1 Products affected

2 Type of change

Product Change Notification					PCN CD, CE, CG - TOX, Label w/o P/N		
owner	creation date	release date	released by	change order	rev	page	
seilerra	03.02.2026	21.08.2026	blumhe		A	1 of 3	D10-097-934

Current product appearance	New product appearance

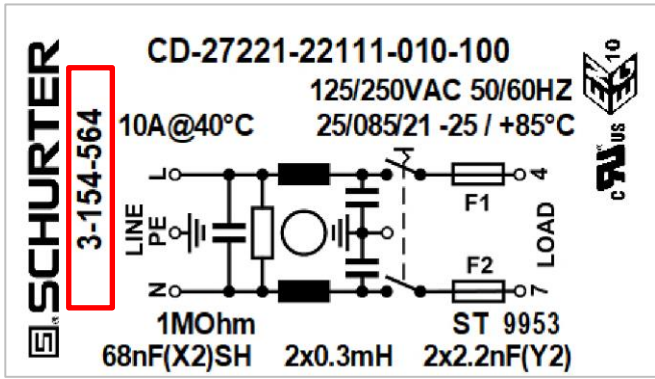
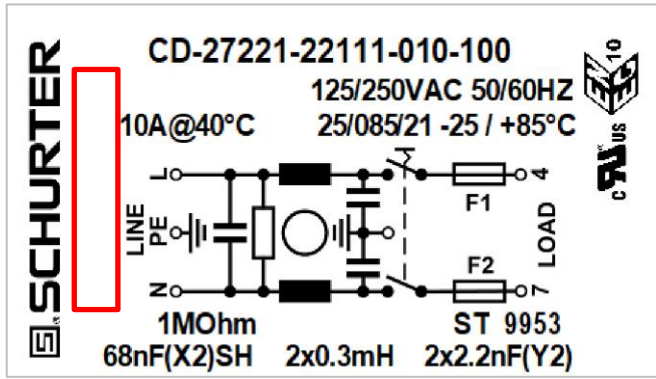
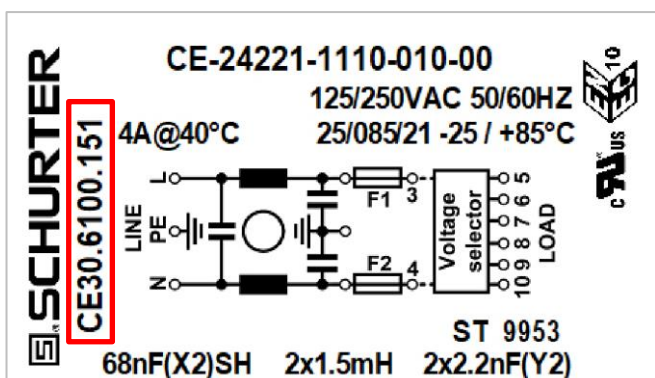
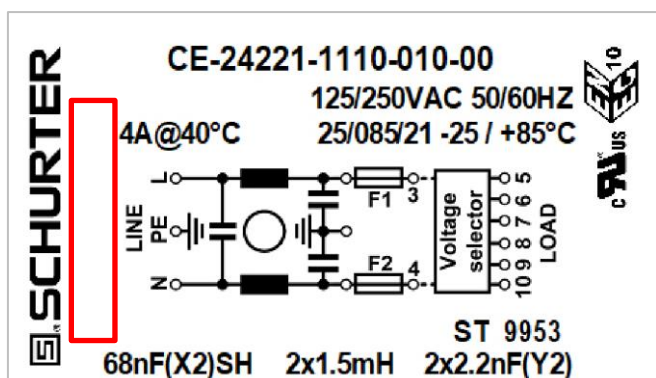
Spot welding joint	TOX clinching joint
Current product label	New product label
 CD-27221-22111-010-100 125/250VAC 50/60HZ 10A@40°C 25/085/21 -25 / +85°C 1MOhm 68nF(X2)SH 2x0.3mH 2x2.2nF(Y2) ST 9953	 CD-27221-22111-010-100 125/250VAC 50/60HZ 10A@40°C 25/085/21 -25 / +85°C 1MOhm 68nF(X2)SH 2x0.3mH 2x2.2nF(Y2) ST 9953
 CE-24221-11110-010-00 125/250VAC 50/60HZ 4A@40°C 25/085/21 -25 / +85°C 1MOhm 68nF(X2)SH 2x1.5mH 2x2.2nF(Y2) ST 9953	 CE-24221-11110-010-00 125/250VAC 50/60HZ 4A@40°C 25/085/21 -25 / +85°C 1MOhm 68nF(X2)SH 2x1.5mH 2x2.2nF(Y2) ST 9953

- Improvement of manufacturing process
- P/N removed from product label

- Production process improvement: Change from spotwelding to TOX clinching
- Production optimisation: Separation of the part and the packaging unit; the configuration code remains on the product, and the item numbers are printed on the packaging label.
- This change is part of the continuous improvement process

The change takes effect in ww 39/2026 (Date code 2639 or higher on label).
Parts on stock will be used upon depletion.
